DESIGN REVIEW & PRESERVATION BOARD
1231 T Street - SACRAMENTO, CALIFORNIA 95814

LOCATION: 1009, 1009-1/2 and 1011 9th Street

PROPOSAL: Facade improvements to a Supportive Structure in the Plaza Park/Central Business District Preservation Area.

PB87-055

EXHIBIT A

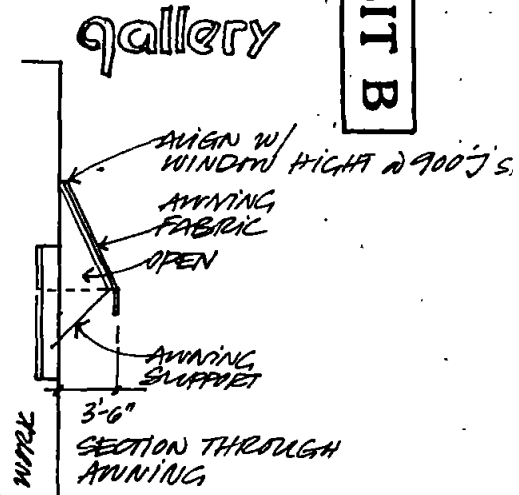
As shown in the Exhibit A photographs, the two story structure has three separate entrances on the lower level. The northerly most door is for stairway access to the upper level which is presently vacant. However, an art gallery is planned to occupy this space in the future. The middle door is to a ground level vacant space to be occupied by a fast food Chinese restaurant called "The City Limit". The southerly most ground level door is to an existing printing business (M and M Printing).

There is an existing metal frame mount for a previous sign which is located between the two center windows on the upper level. All remnants of this previous sign should be removed and any necessary repairs to the facade after its removal should be made. Also, the exterior wires over the stairway door should be removed. Repairs to the upper level windows should be made as necessary. The existing wood door to the stairway should be removed and replaced with a glass door to match the other entrances.

7. The awning material shall be a fabric that is fire treated or non-flammable.
8. The remnant framework used for a previous sign on the upper level shall be removed and any repairs necessary to patch the facade shall be made.

10. Exterior wiring should be removed.
11. The stairway door should match the other two glass and anodized aluminum doors.
12. The ground material of the newly recessed area shall be exposed aggregate to match the ground material used in the recessed area of the print shop.

EXHIBIT B

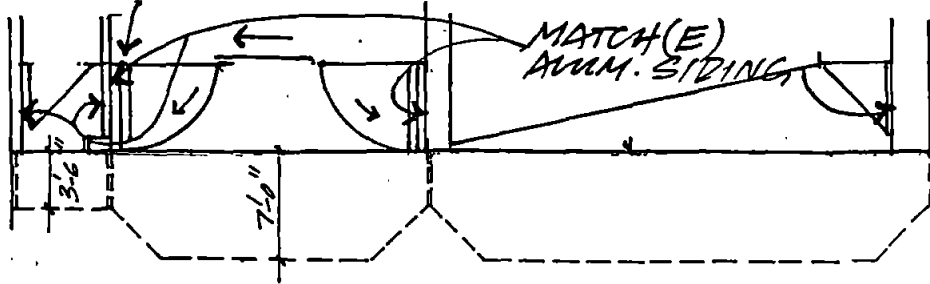
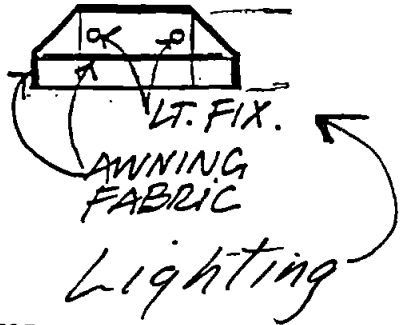
The proposed project is shown in the drawing elevation, Exhibit B. The majority of the remodel is to the facade area of the new restaurant. In this area, the present frontage will be replaced with a new glass and anodized aluminum storefront to be compatible in materials and design to the existing print shop frontage which will remain (see Exhibit C). The applicant has indicated an approximate height of the window system to be 8', 6" and a length of approximately 13 ft., 10 and 1/2". The original proposal for the restaurant frontage shown in Exhibit B has been deleted because the Fire Department did not support it. The large glass windows that slide to the side to create an open air storefront create a potential safety hazard for fire escape purposes.

The door of the existing print shop is recessed back four feet from the front property line. The rest of the storefront gradually angles forward from the door until it meets the sidewalk as shown in Exhibit B (drawing is below the elevation). The applicant proposes to recess the restaurant storefront and stairway door back four feet with a wing wall between the two ground level use entrances. Solid anodized aluminum panels will be placed on each side of the wing wall to match the inner recessed wall of the print shop. The new recessed area will have a stucco soffit. A new horizontal stucco panel will be placed between the base of the tile located on the upper level, and the head of the window wall, where the stucco panel and soffit will come together.

It is important that the new anodized aluminum material used in the new window system and wing wall match the color of the anodized aluminum used at M and M Printing.

The ground material for the new recessed area should match the exposed aggregate ground material used in front of M and M Printing. The soffit above the print shop entrance should be covered with a thin coat of stucco for a uniform look.

The new stucco horizontal band at the head of the window wall and the stucco soffit should match the color of the awning in the same location. Therefore, the stucco areas should be burgundy at the stairway entrance and off-white above the print shop and restaurant. All awnings should be fire treated or non-flammable.

1. The height of the window and door front system for the new restaurant shall be 8 ft. 7 in., to match the height of the window and door system of M and M Printing.

2. The lowest horizontal member that divides the windows of the restaurant shall be 2 ft., 7 in., from the edge of the base frame in order to match the print shop window system.

3. The color of the anodized aluminum used in the remodeled area shall match the anodized aluminum color (dark bronze) at M and M Printing.
4. Large anodized aluminum panels of the same design and color used on the recessed interior wall at M and M Printing, shall be used on the recessed wall areas of the remodeled area, including the wing wall.

5. The color of the stucco soffit and the stucco horizontal band above the window head wall shall match the color of the awning in the same location. This would be burgundy above the stairway door and off-white above the print shop and restaurant.

6. The new recessed areas shall be four feet deep to match the depth of the existing print shop.

EXHIBIT C

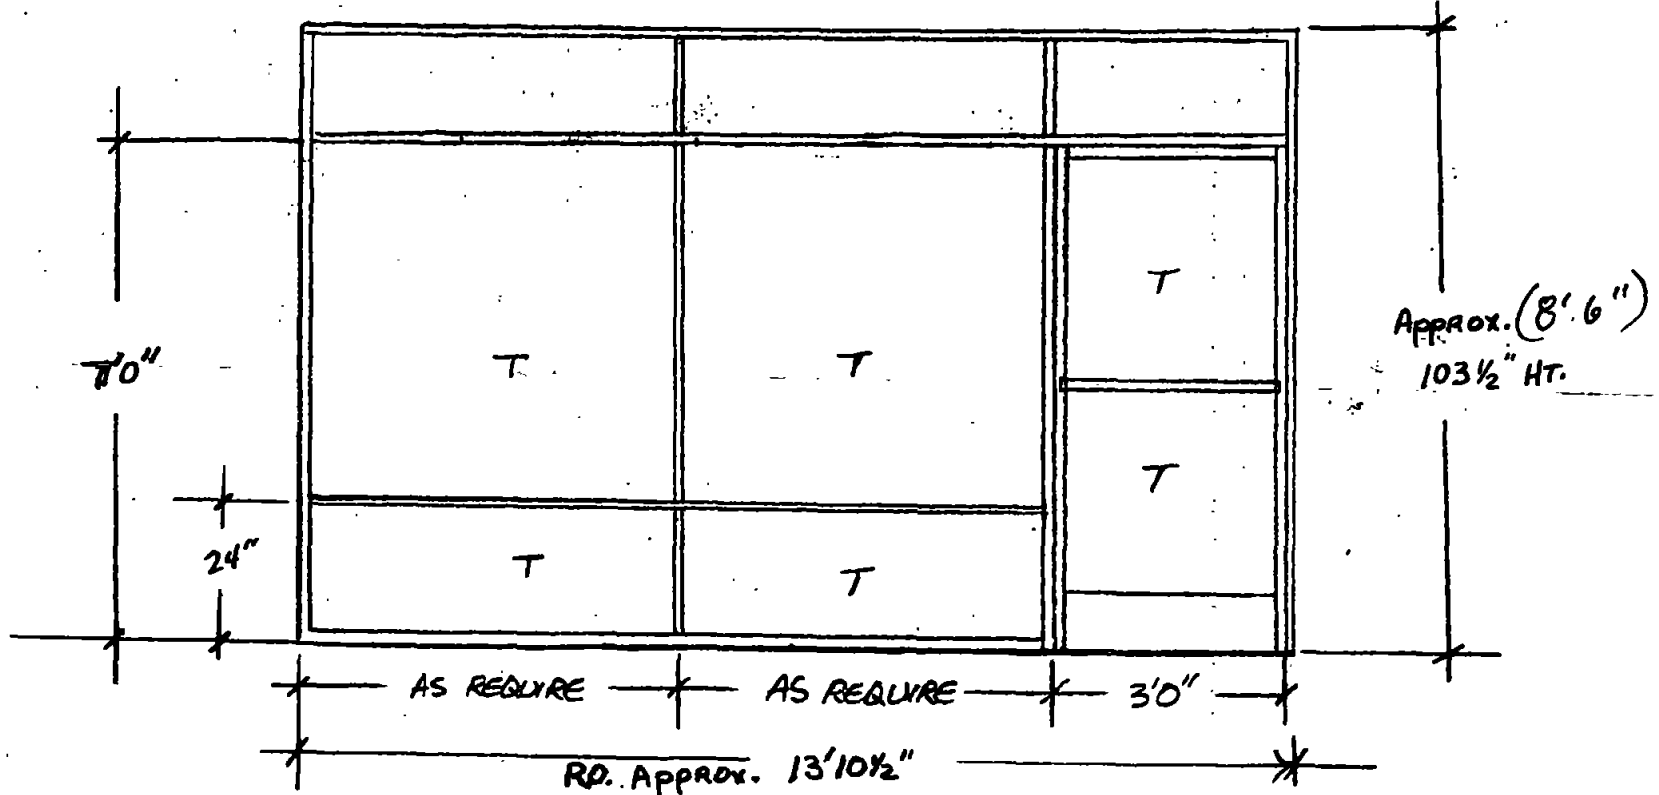
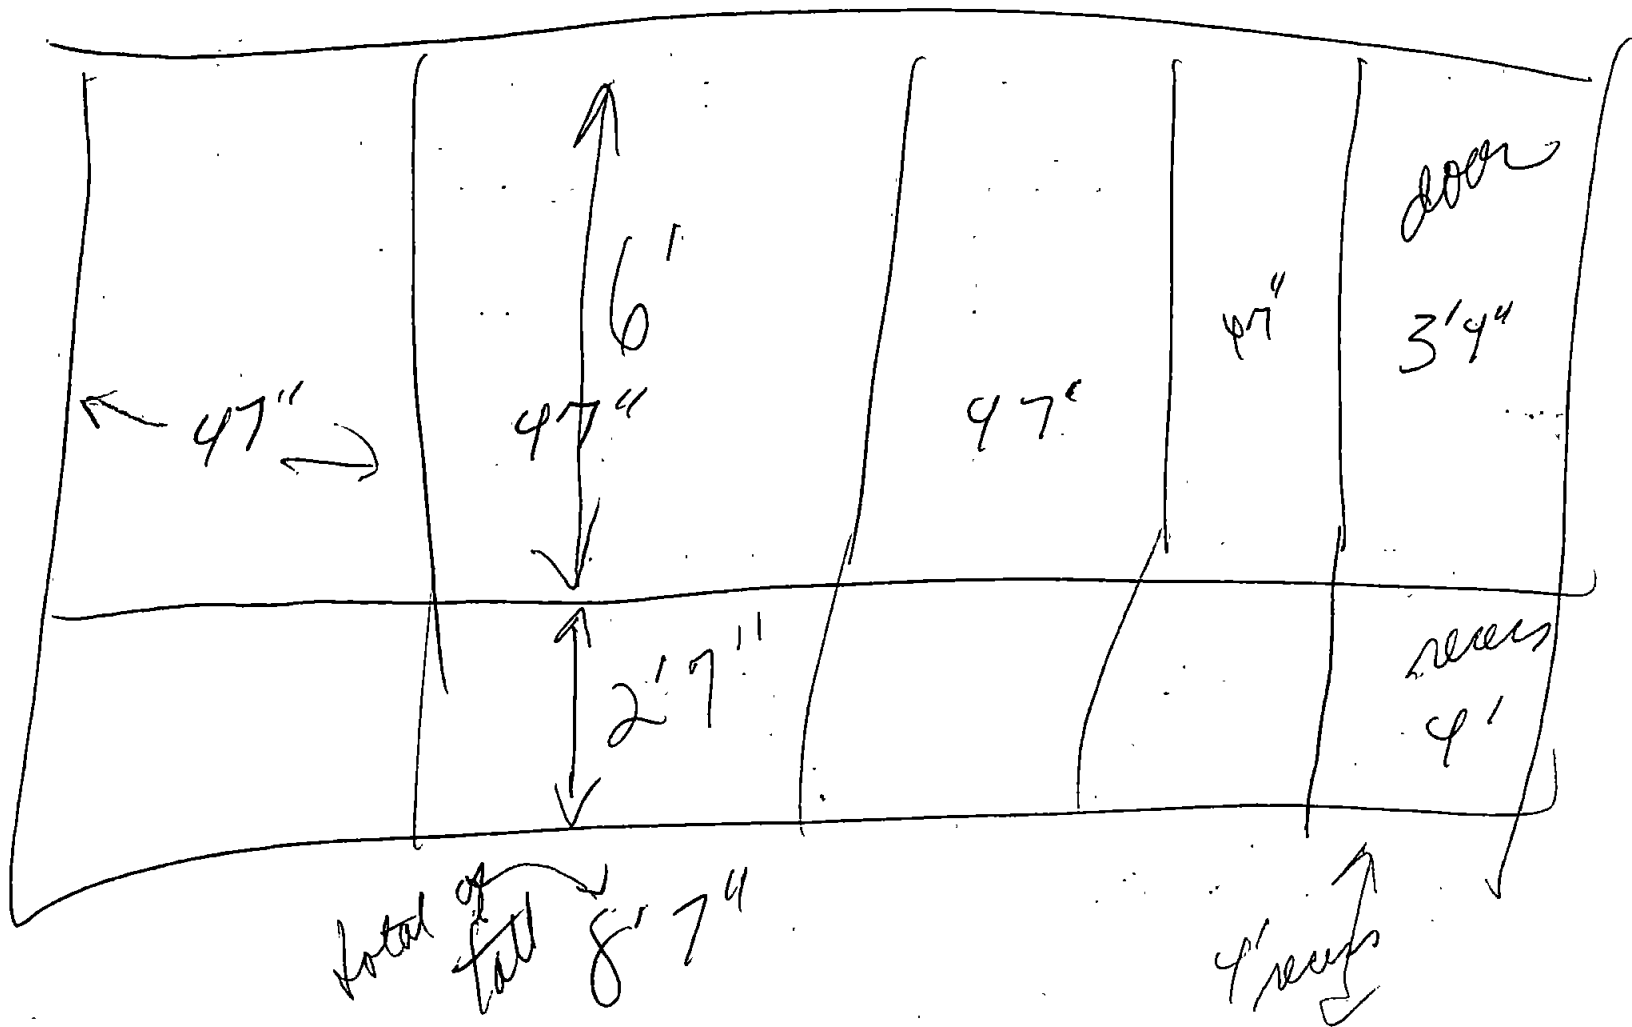
New fabric awnings are proposed on both the upper and lower levels. The awnings for the lower level are shown in Exhibit D. The longer awning (22 ft. 6 in.) will replace the existing awning over the print shop and will have "M and M Printing" on the skirt of the awning with 10 inch high letters. The 14 ft. 9 in. awning will go over the Chinese restaurant and the skirt of the awning will have a sign reading "City Limit" in 10 inch high letters. These two awnings will be in off-white. Lower level awnings will be back lit. The awnings over the stairway is shown in Exhibit C along with the design of the four upper level awnings.

13. The frame of all awnings shall match the color of the awning fabric.
14. A flat horizontal piece of fabric should be placed inside the awning above the awning skirt to hide interior light fixtures. It should be the same material and color as the outside awning fabric. A space should be provided between the horizontal interior fabric edge and the outside fabric to allow light to escape downward.

EXHIBIT D

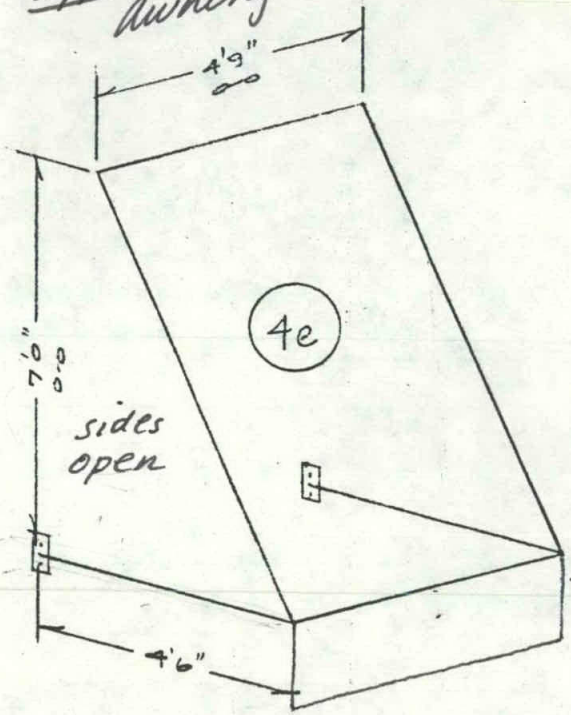
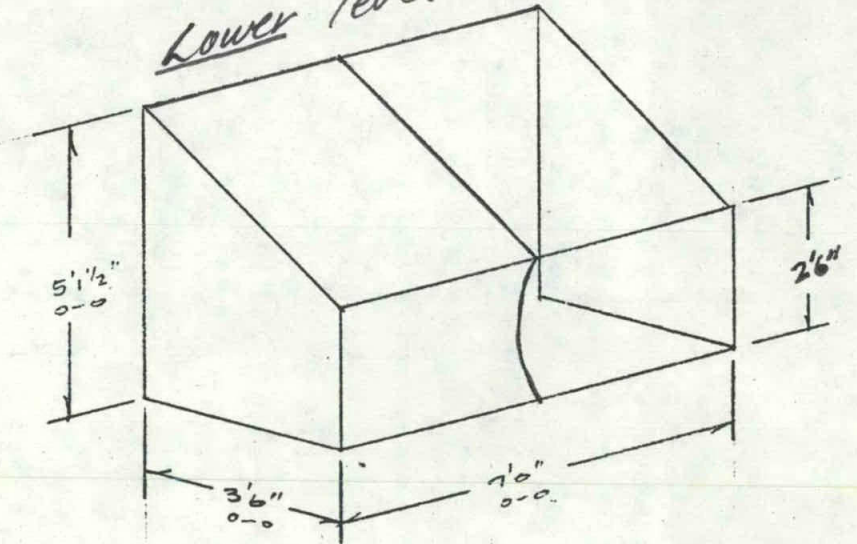
The back side of lower level awnings will have a vertical piece of fabric fitting close to the building wall. In order to hide the light fixtures inside the awning, a horizontal piece of fabric will lay flat above the awning skirt. The edges of this inner piece of fabric will not meet with the outside fabric in order to leave a space for light to escape downward toward the sidewalk. The upper level awnings will have fabric along the front only and the sides will be open. The word "gallery" will be on the upper level awning skirts in letters less than 10 inches high.
